Application for Licence Amendment

Licence Number	L6798/1993/12
Licence Holder	TT Sand Pty Ltd
ACN	064 072 322
File Number	DER2015/000288-1
Premises	Mindijup Silica Sand Mine 570 Mindijup Road PALMDALE WA 6330 Being Mining Tenement M 70/793 Legal description – Lot 5 on Plan 62329 Certificate of Title Volume 1629 Folio 660 As defined by the premises map in Schedule 1 of the Revised Licence.
Date of Report	4 December 2023
Decision	Revised licence granted

Figure 2: Distance to sensitive environmental and human receptors within 2 km from the screening plant, processing plant and stockpiles.

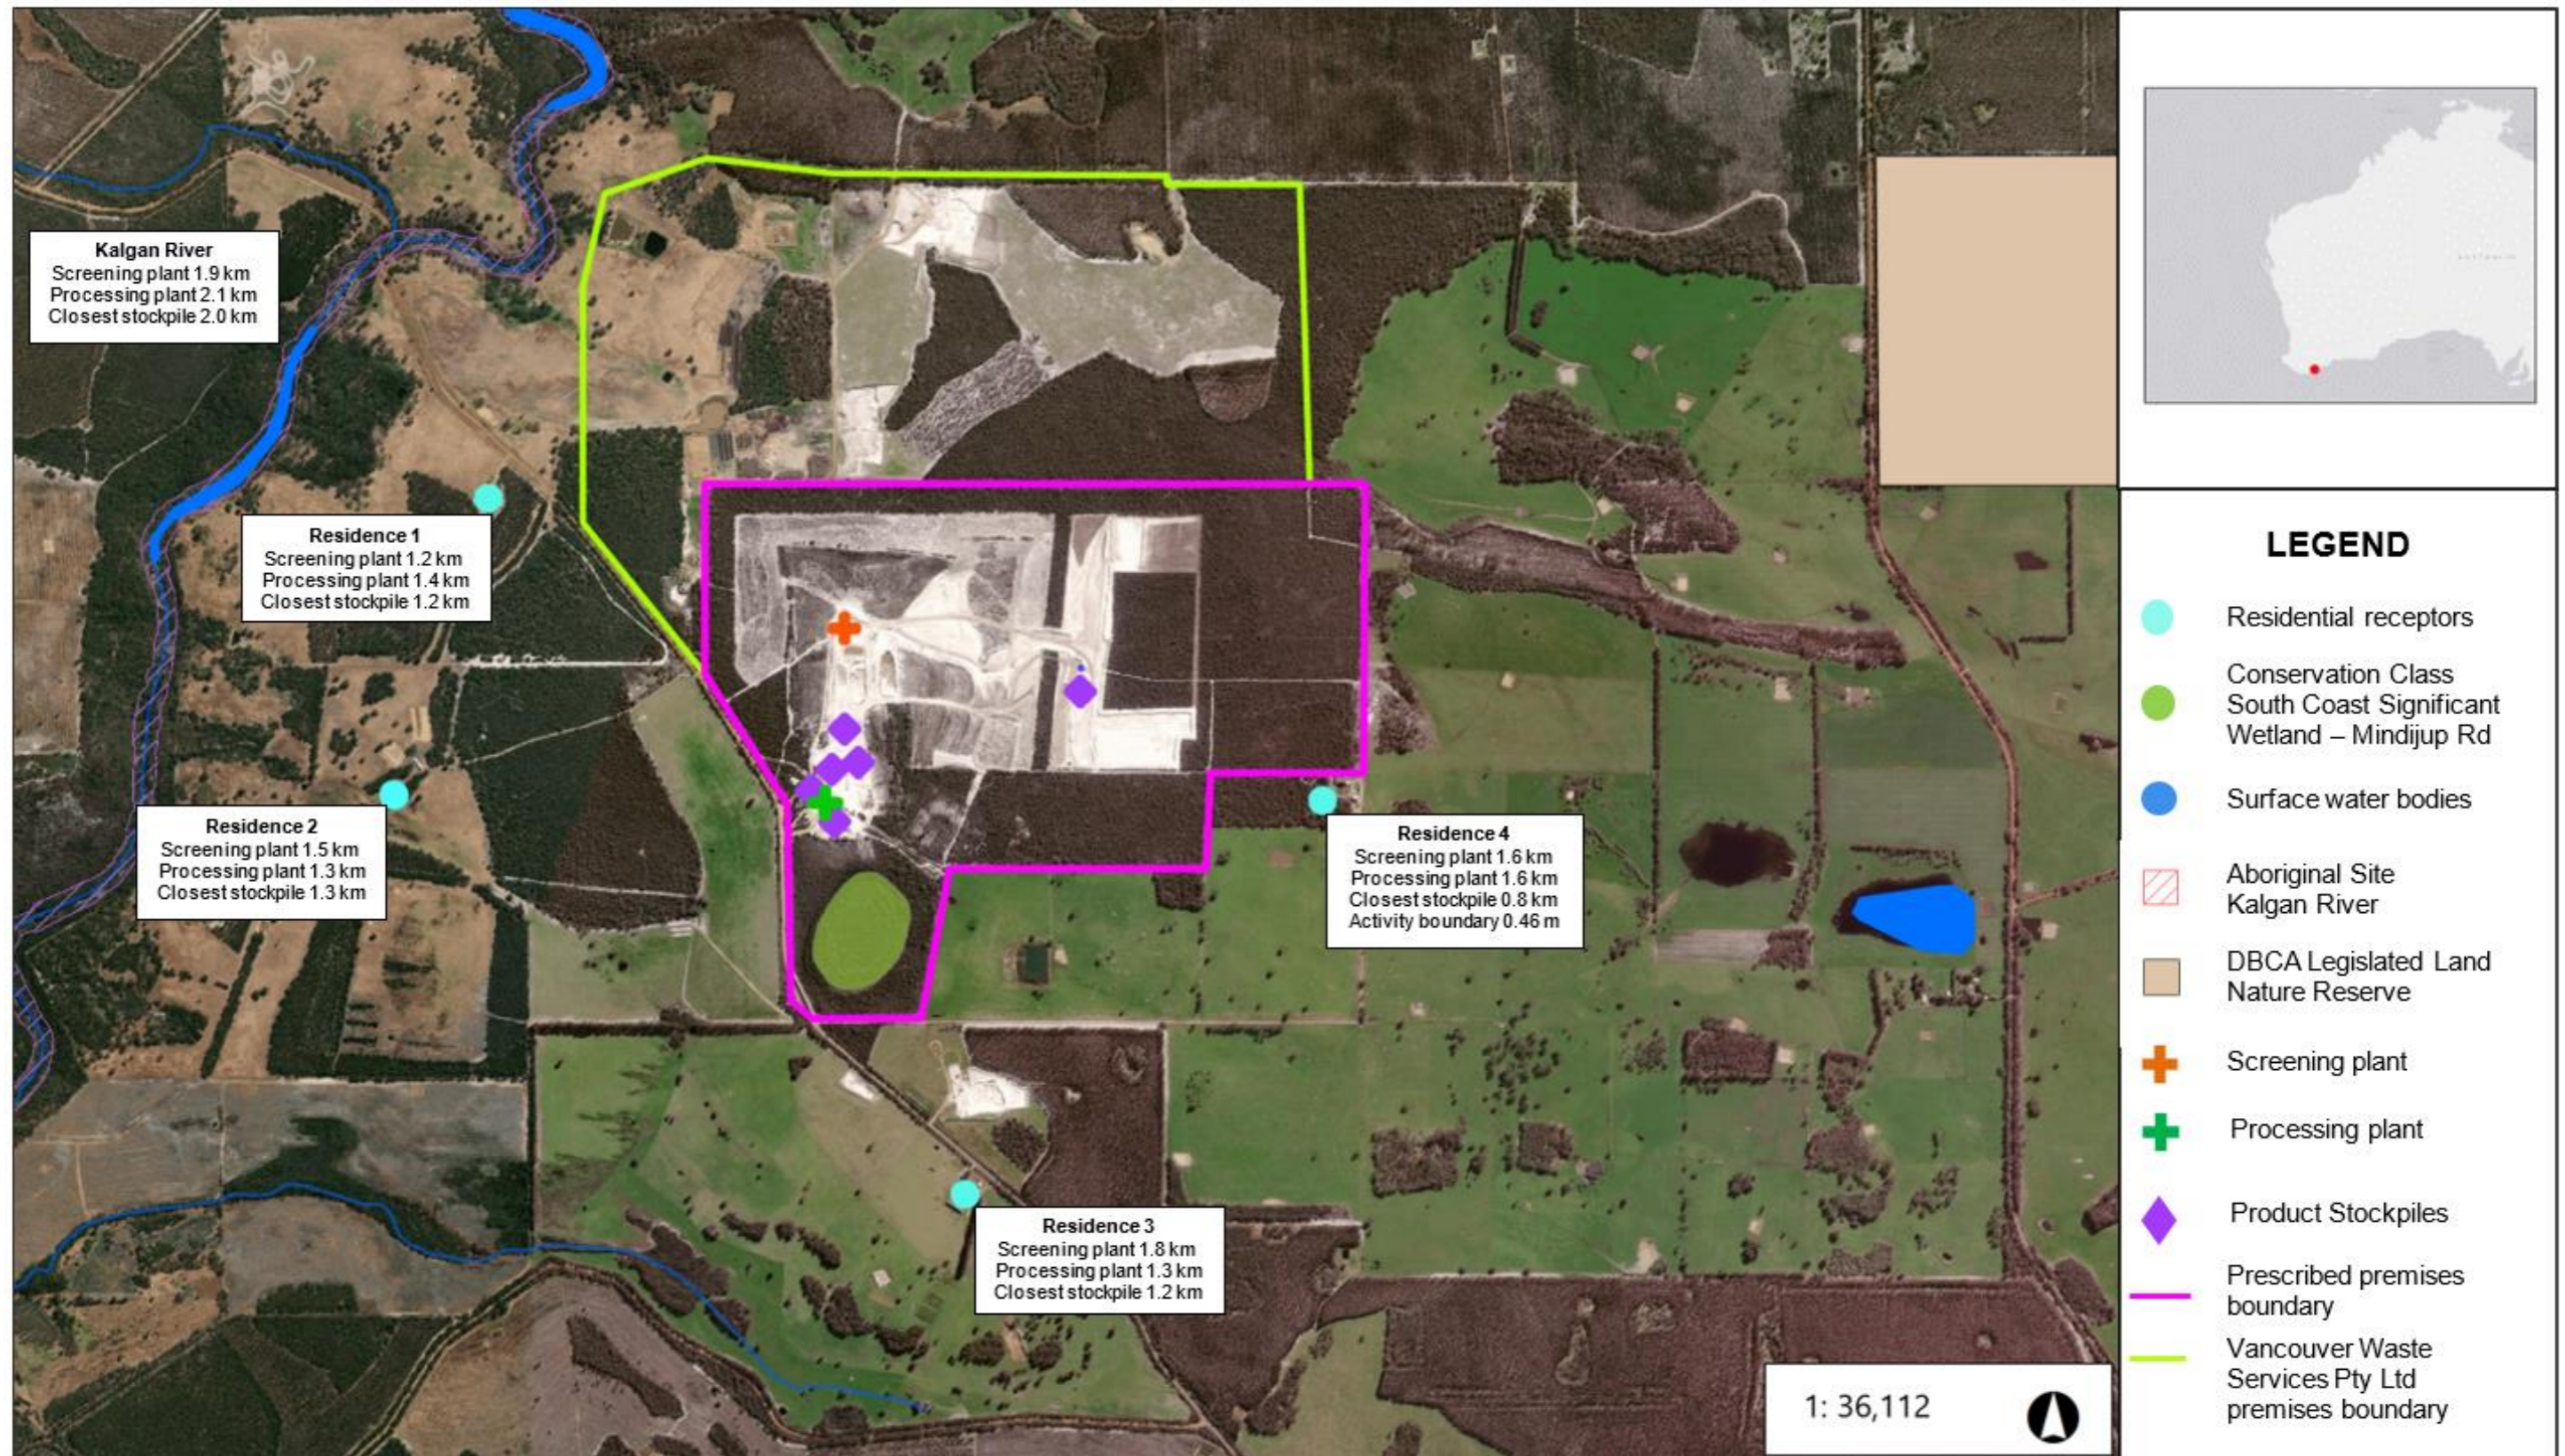
The southeastern residential receptor (residence 4) is located 80 m from the premises boundary, 800 m from the closest stockpile and approximately 460 m from the edge of the activity boundary; therefore, the distance between ground disturbing activities and residence 4 is currently less than 500 m, the upper range of the recommended separation distance of 300 to 500 m outlined in *Guidance Statement No. 3: Separation Distances between Industrial and Sensitive Land Uses* (EPA, 2005). Where separation distances provided in the Guidance Statement are not met, the likelihood of impacts increases.

Currently, the separation distance between sources of fugitive dust emissions and residence 4 (Figure 2) is deemed sufficient not to trigger a more detailed assessment. However, as the activity boundary moves east due to expansion of mining activities, the buffer distance is likely to reduce to be less than 500 m, requiring a more detailed analysis. The addition of dust monitoring and revision of the dust management plan as outlined in conditions 6, 7 and 8, will demonstrate whether the reduced distance from the source of emissions to residence 4 will result in increased emissions reaching the receptor and if increased emissions are identified, the revised dust management plan will trigger management actions that will be employed to mitigate and minimise the impacts of potential silica dust emissions.

The area defined in Figure 3 of the Revised Licence employs a 430 m (+/-10m) separation distance from residence 4 sensitive land use activity boundary to the industrial land use activity boundary and is within the recommended separation distances of 300 to 500 m for sand extraction activities as outlined in *Environmental Protection Authority - Guidance for the Assessment of Environmental Factors: Separation Distances between Industrial and Sensitive Land Uses No. 3*. Due to the substantial increase in throughput, the severity of respirable silica health impacts, hours of operation (24 hours per day and 5 days per week), and with consideration of the licence holder's comments outlined in Table 5, a 430 m separation distance is selected. Technical advice sought from the department's Air Quality Branch was utilised to inform the risk assessment and the requirements outlined in conditions 6, 7 and 8.

Figure 3: Wind rose from DWER Albany Air Quality Monitoring Station (2017-2022)

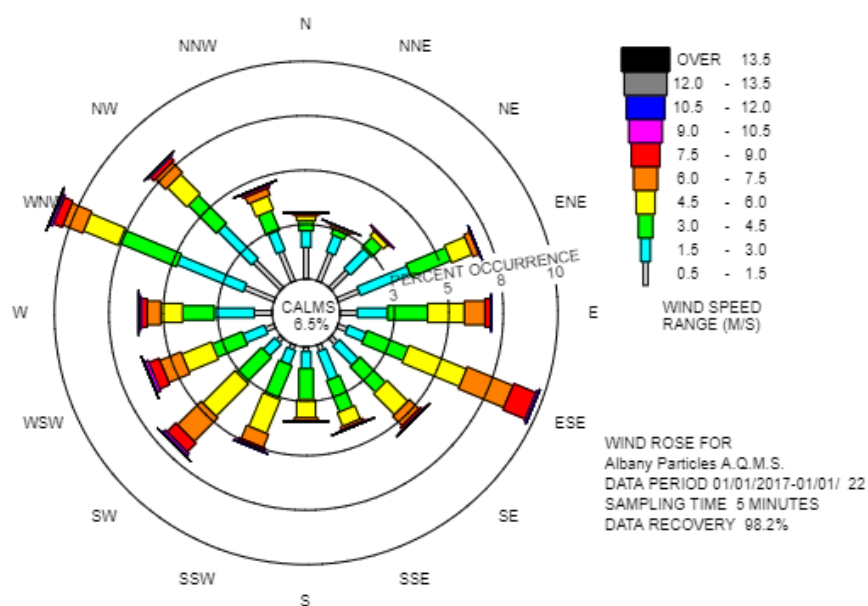
Dust is transported via windborne pathways; therefore meteorological conditions are determinants of dust migration. Wind rose data taken from the department's Albany Air Quality Meteorological Station is representative of meteorological conditions at the premises, and shows annual (Figure 3) and seasonal autumn, winter and spring (Figure 4) predominant wind direction and strength for 2017 to 2022 to be from the west-northwest; therefore it is likely that dust may migrate towards residence 4 (south-east of the premises). Where rainfall is low and temperatures are high, stockpiles, roads and reject material have the potential to dry out, increasing the likelihood of transmission via wind-borne pathways. Although most west-northwesterly winds are in winter months when rainfall is higher and soil moisture is likely to be retained, dust migration is possible in the event of reduced rainfall.
